# CITY OF ALBUQUERQUE

**RE: Signal Village Subdivision  
Signal and Ventura NE  
Grading Plan Stamp Date: 2/20/19  
Drainage Report Stamp Date: 2/20/19  
Hydrology File: C20D078**

**Re: Signal Village Subdivision Grading Plan and Drainage Report (C20D078)**

# Profile View of Subdivision North Scour Wall

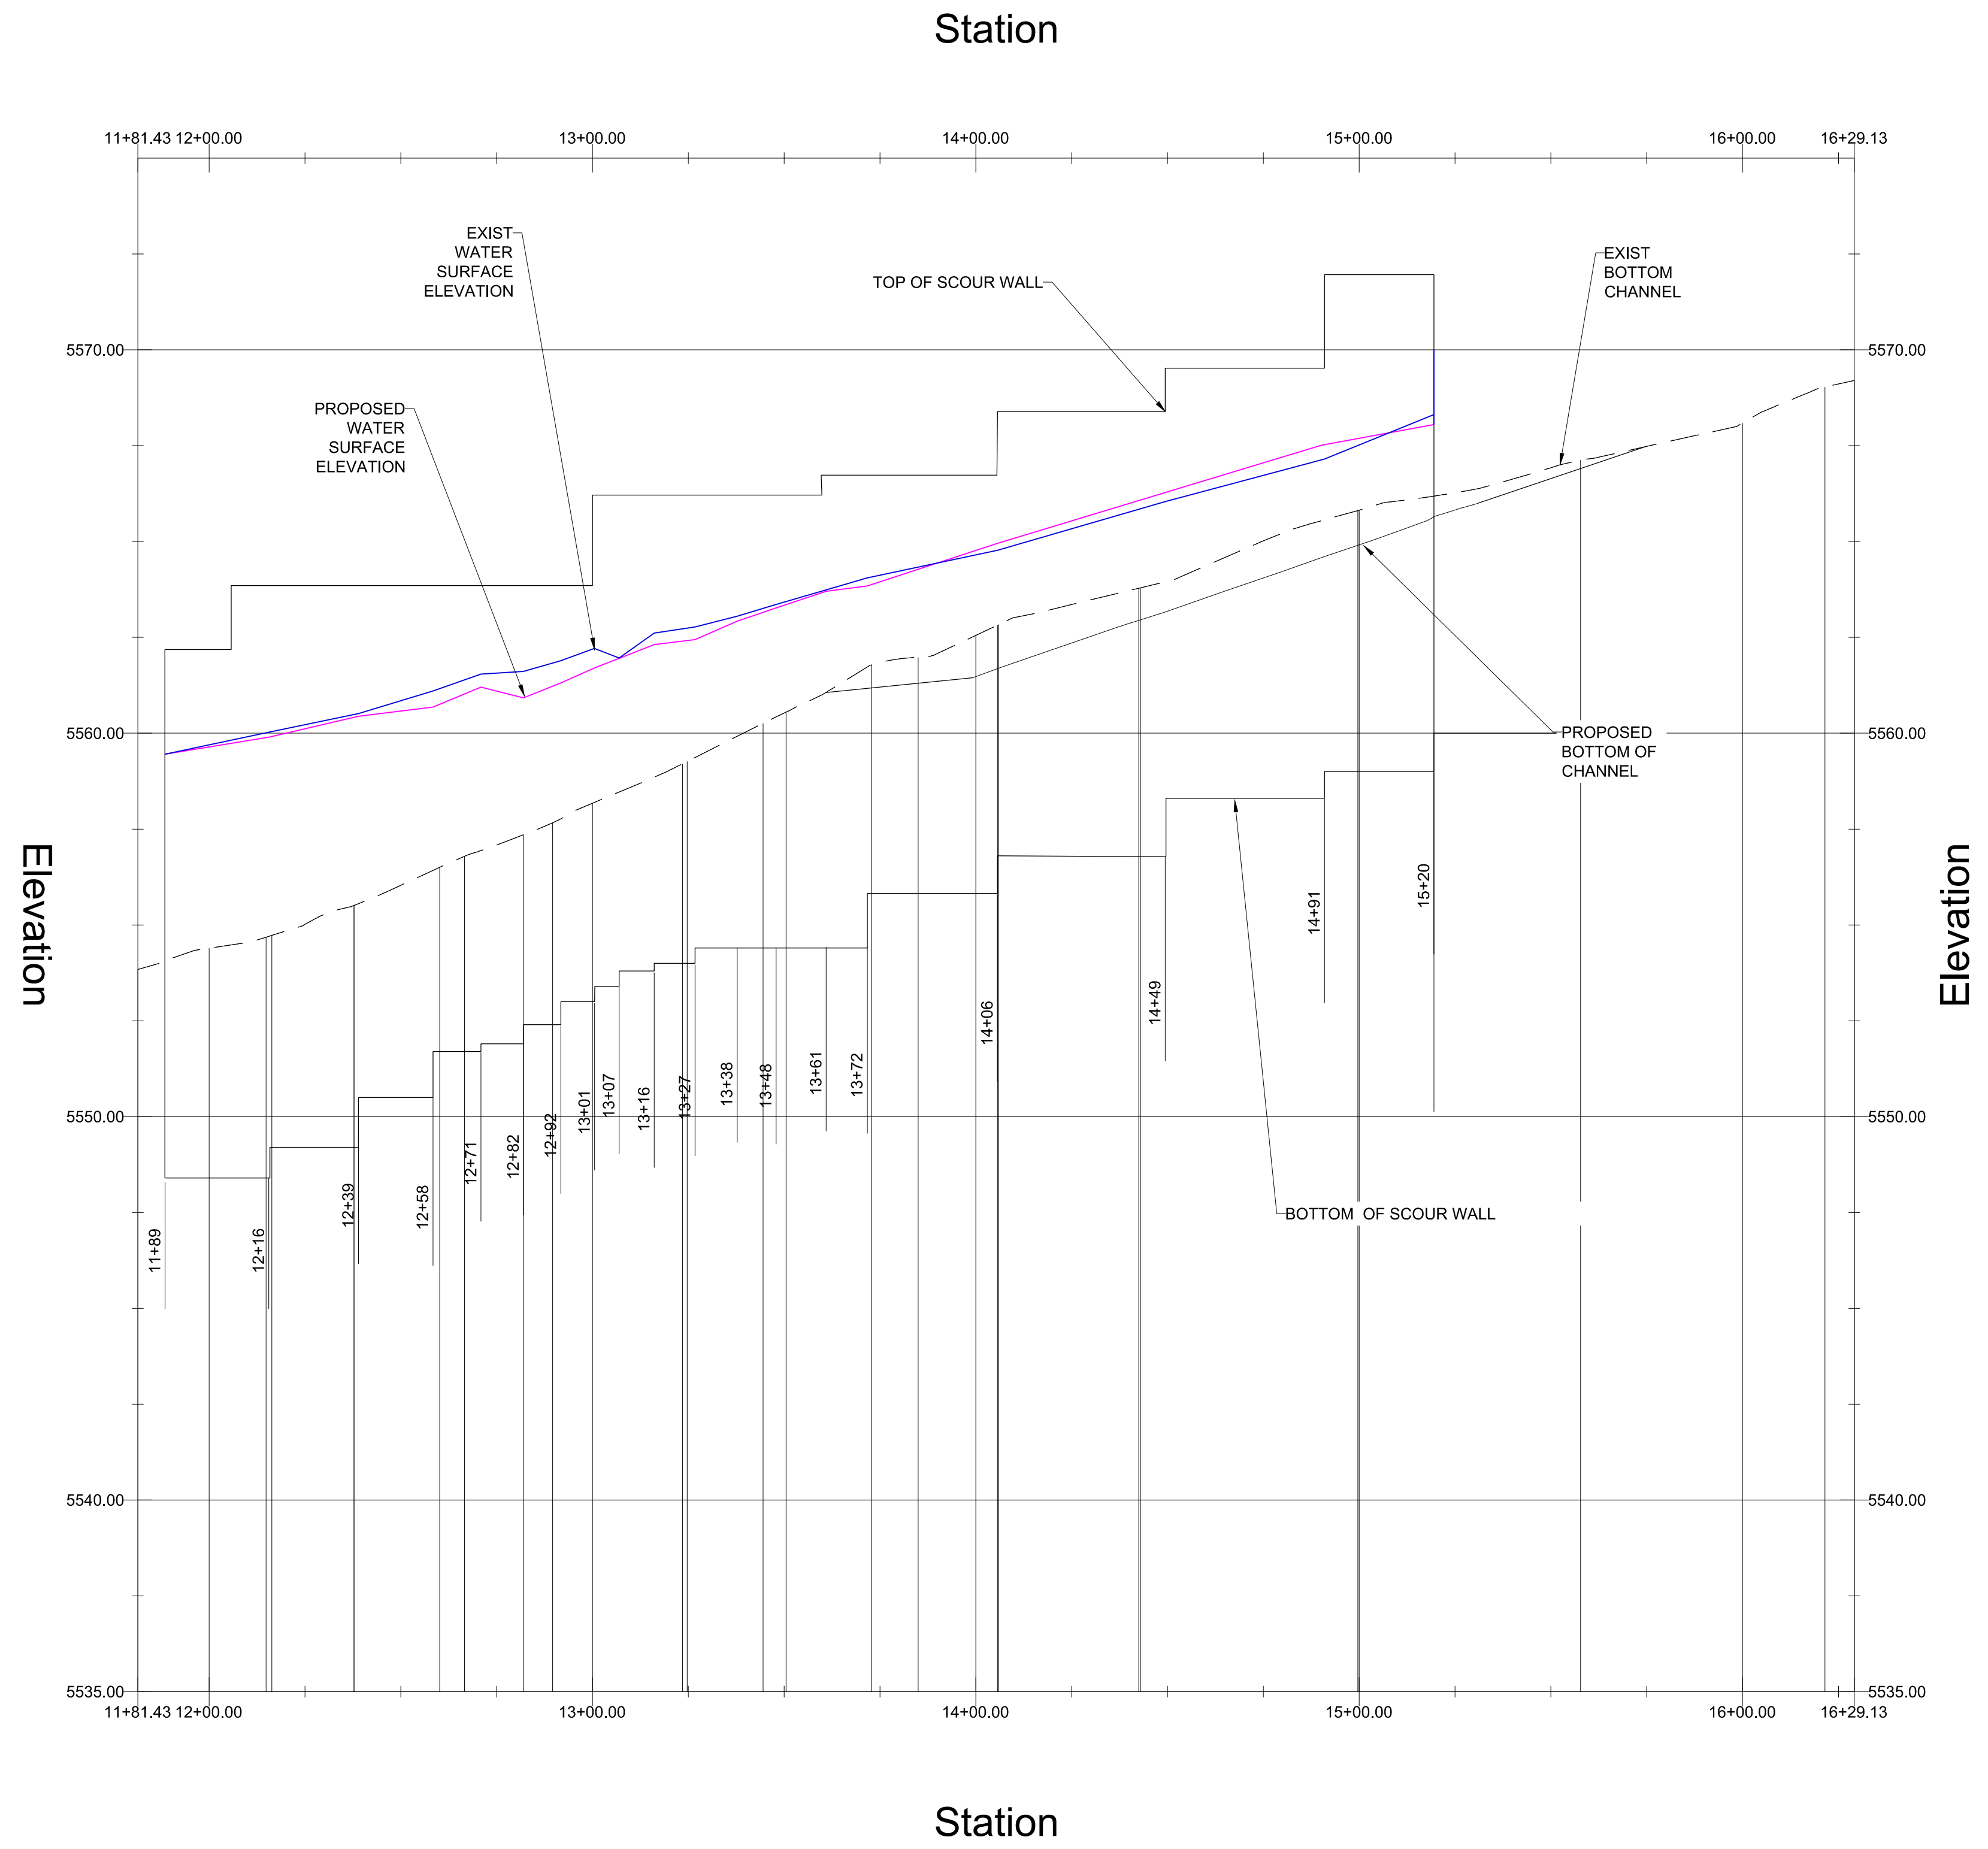
11. **Comment:** The scour wall is shown as being constructed from CMU block which is constructed in level runs, but the profile shows the scour wall as sloping along its length. The location of the steps should be called out on the plan for the footer and top of wall.

14. **Comment:** On the profile of the arroyo and proposed scour wall, provide proposed grades through the future culverts, provide elevation of the finished grade on both side of the wall, top and bottom of the wall (these should match those shown in the plan view), correct bottom of wall label, confirm that the water surfaces shown are for the critical or subcritical depths (not supercritical). Show as-built elevations of existing downstream floodwall based on new survey, not engineer's certification from Signal Pointe because that datum is inaccurate.

**Response:** The scour wall profile has been revised. All bottom and top of wall elevations are shown on the plan.

**Response:** Proposed grades have been provided on the arroyo profile.
